TSB130099
-----------

ECM Calibration and Aftertreatment SCR Catalyst Compatibility on ISX12 CM2350 X102 and ISX15 CM2350 X101 Engines

Figure 1, Aftertreatment SCR catalyst heat shield dimples

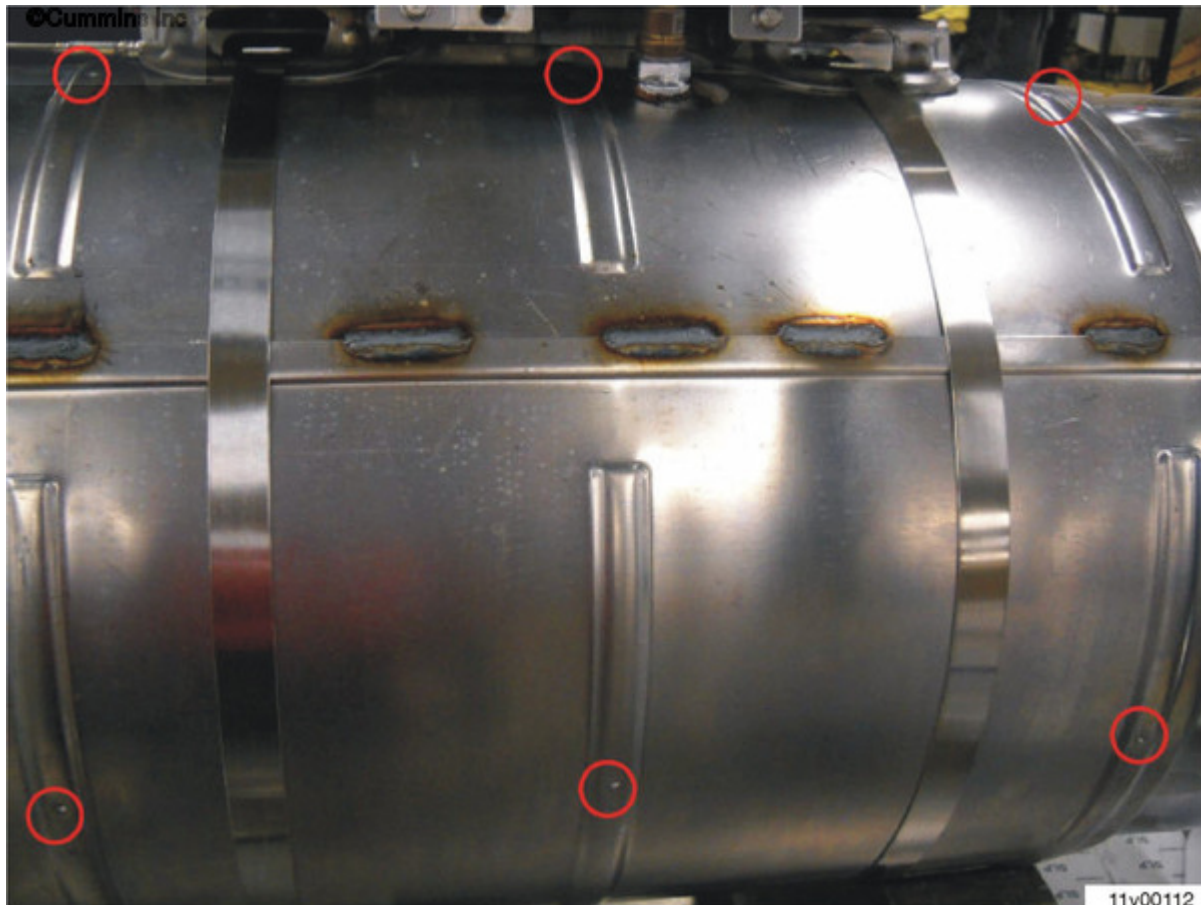
Aftertreatment SCR catalysts that are compatible with ECM Calibrations released after June 21, 2013 can also be visually identified by dimples in the aftertreatment SCR catalyst heat shield. These dimples go around the circumference of the aftertreatment SCR catalyst heat shield and can be found in 3 different locations equidistant around the circumference. See Figure 1.
